GLENWOOD HIGH SCHOOL UPGRADE

CIVIL ENGINEERING DESIGN REPORT

PROJECT: Glenwood High School Upgrade
Project No: 6393

COUNCIL TRACKING SPREADSHEET AND OSD
CORRESPONDENCE

status			
scale at A1 1:250	drawn by PAD	checked KEH	
project no. 6393	drawing no. CV-0200	rev. B

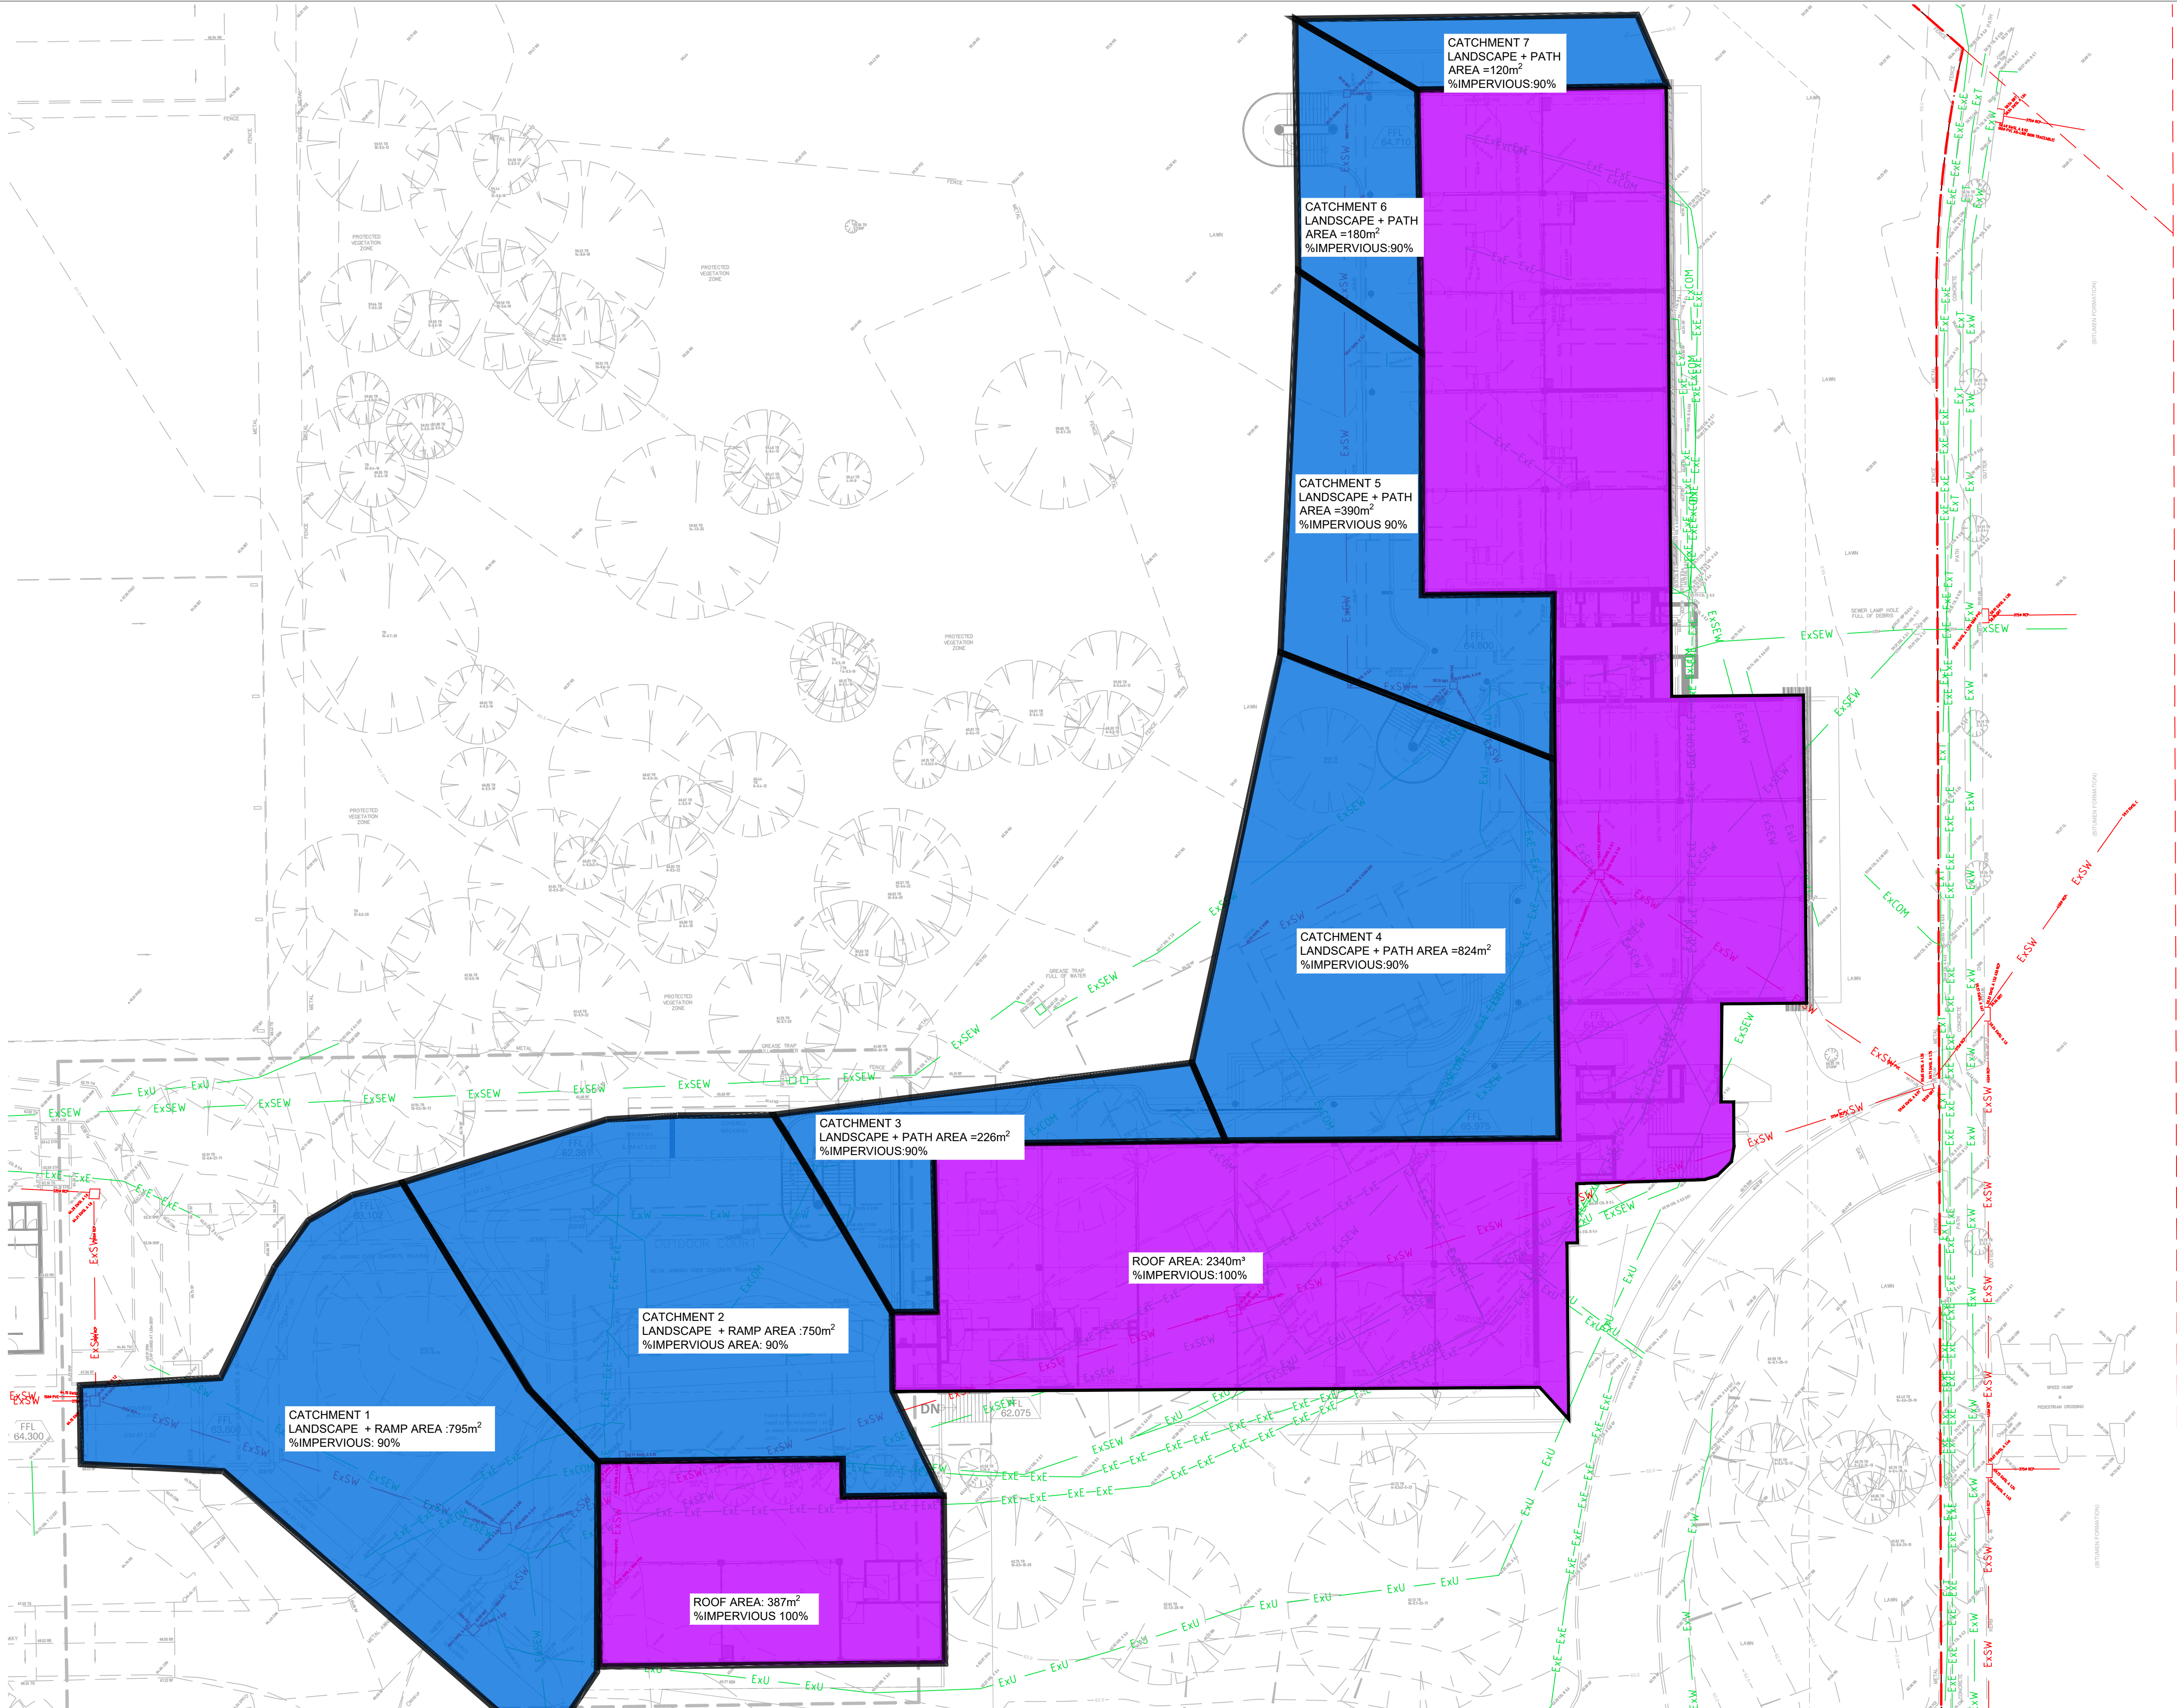
27	It is unclear whether Pits 18 and 27 are treating surface flows and all or only part of the upstream pipe flows as well. Provide detail for Pit 18 and 27 showing all invert levels for all pipes.	Catchment plan CV-0200 now included. Pits grate size and type upgraded to suit catchment plan. Refer to pit size schedule on CV-0001
28	OceanGuards should treat a maximum of 1000 m2 of non-roof areas and 1500m2 of roof areas. All OceanGuards are to be clearly notated as "200 micron OceanGuards".	Catchment plan CV-0200 now included. Oceanguard detail noted on drawing CV-0212 as 200microns. Refer to report section 6.1.2 for Oceanguard reference and correct 200micron notation
29	OceanGuards treating only surface flows require a minimum clear depth of 500 mm below the grate to any inlet or outlet pipe obvert. OceanGuards treating surface flows and upstream pipe flows require a minimum clear depth of 500 mm from the invert of the upstream pipes to be treated, to the obvert of the outlet pipe. Where these pits are treating upstream pipe flows the inverts of all pipes in and out of the pit are to be shown.	Pipe invert and pit levels provided onto drawing CV-0201 which indicates the oceanguard pit baskets are above the connecting pipes.

68	The area above the on-site detention storage itself and the catchment areas draining to it are considered as bypass where they do not enter the Stormfilter chamber.	Catchment plan drawing CV-0200 added to the drawing set showing pit and pipe catchments. There is no intended bypass from the proposed development
69	Resubmit all models and OSD Deemed to Comply Tool spreadsheet electronically for Council assessment.	OSD deemed to comply tool spreadsheet has been updated and is submitted on the onedrive link for review. Refer to the civil report Appendix B for submitted spreadsheet
71	Clearly show details of all pits including surface levels and invert levels.	Drawing 0201 now shows stormwater pipe inverts and pit levels
72	Provide more details for the Stormfilter tank such as false floor level and thickness, impermeable battle distance upstream of Stormfilter weir etc.	Drawing 0213 has been updated with 100mm false floor, baffle distance, and operation with a sealed lid

status	scale at A1 1:250	drawn by NKK	checked KEH	rev. I
project no. 6393	drawing no. CV-0201

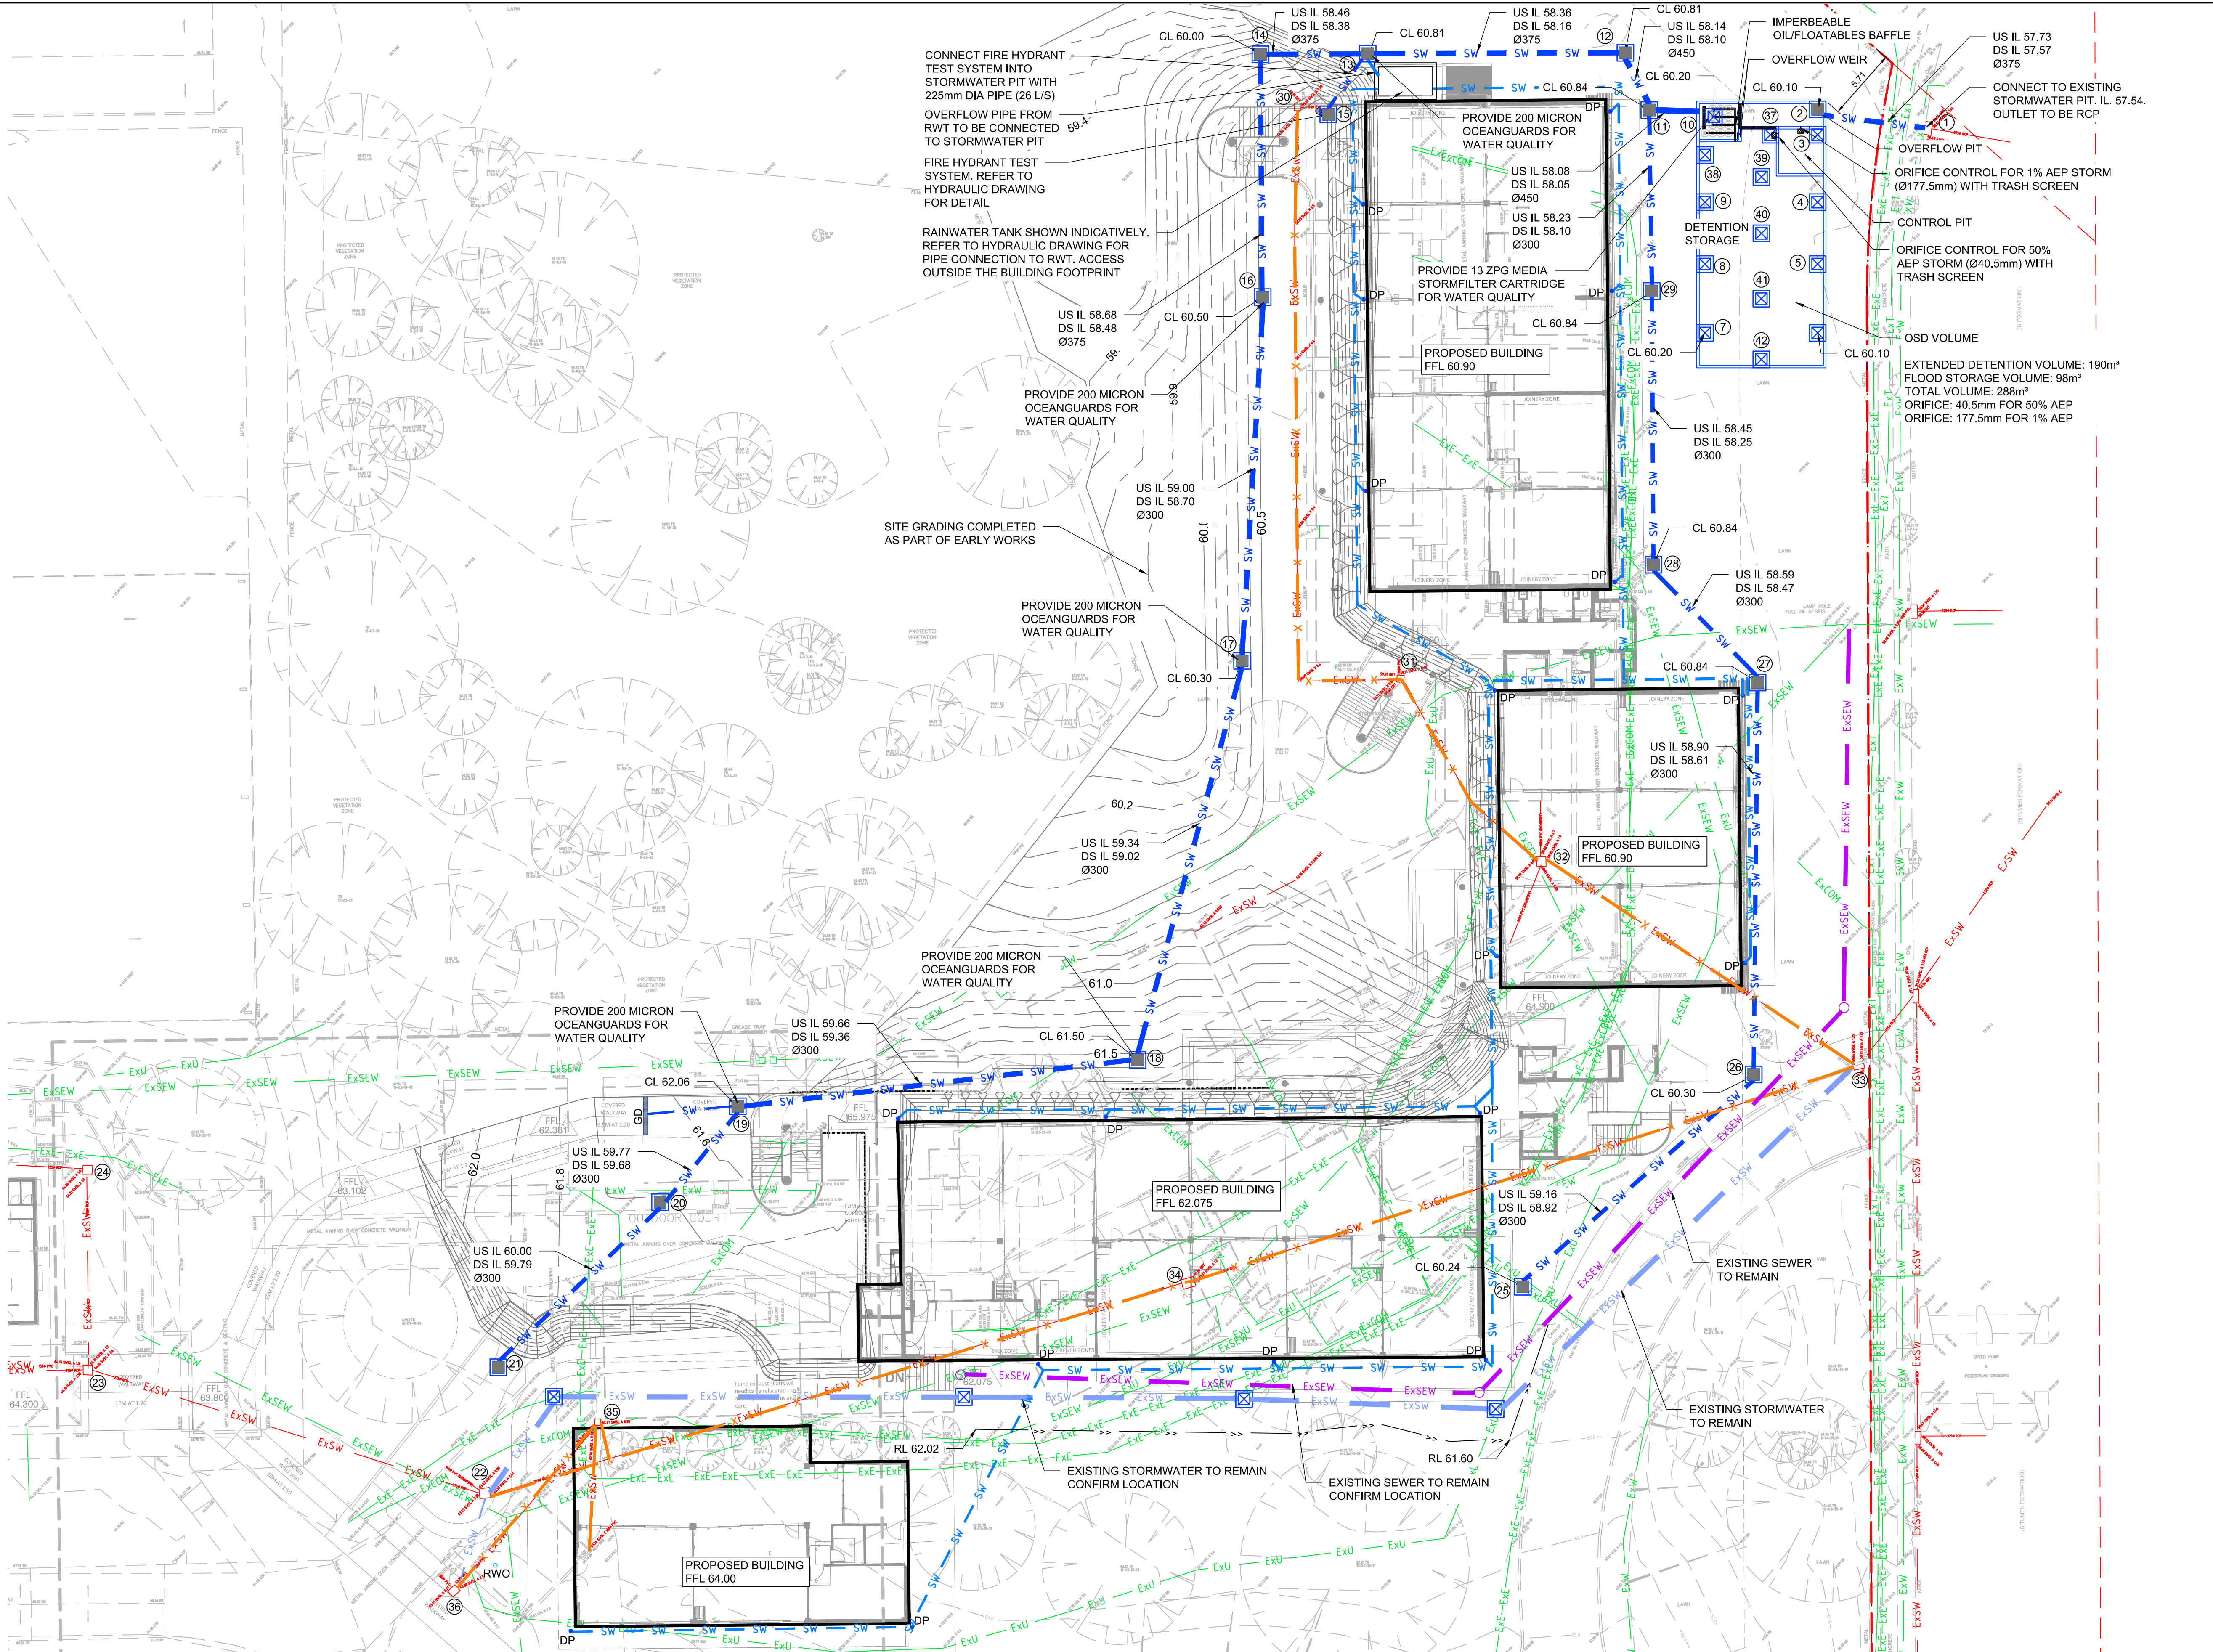
23	Show how the roof water gets to the rainwater tank. Provide a separate system for roof water and surface drainage. Pits between the roof lines (i.e. charged pipes) are to be sealed.	Downpipe locations shown on drawing CV-0201. Downpipes are collected and discharged into the rainwater tank. The pipes from the roof are separate to the in-ground stormwater system
24	Provide details of the rainwater tank including pre-treatment, volumes, sections, dimensions etc.	Rainwater tank volume added to CV-0201 and the civil report. Pretreatment information referenced in the civil report - refer section 6.1.4. Hydraulic report added to the Appendix G of the civil report.
25	The 375 mm diameter outlet to the existing stormwater Pit 1 is to be RCP.	375mm dia pipe noted on RCP on drawing CV-0201
26	Provide levels of the existing street Pit 1 and confirm the connection level to this pit.	Existing pit 1 and connecting pipe level information added to drawing CV-0201

75	Check drawing 0201 (A) is correct because it seems some notations have been cut off at the top of the page	Redundant leader removed
76	Confirm whether OceanGuards treats a maximum of 1000 m2 of non-roof areas and 1500m2 of roof areas;	All roof areas, as shown on 0201 are directed to the RWT for cleaning and reuse. It is confirmed that non roof area draining to pits have an area no greater than 1000m2. Refer catchment plan 0200
77	The targets indicated in Section 6.1 of the Civil Report seem to be missing the 90% target for total hydrocarbons that is required under Part J of Council's DCP	No hydrocarbons are specifically targeted as none are being produced i.e. no additional parking is being provided on the site, from which, it is not possible to reduce hydrocarbons by 90%
78	CV-0001 seems to be missing some numbers between 1 and 42	Only proposed pits or existing pits with changes are shown in the schedule - existing pits are numbered in plan however if no changes are proposed they are not in the schedule
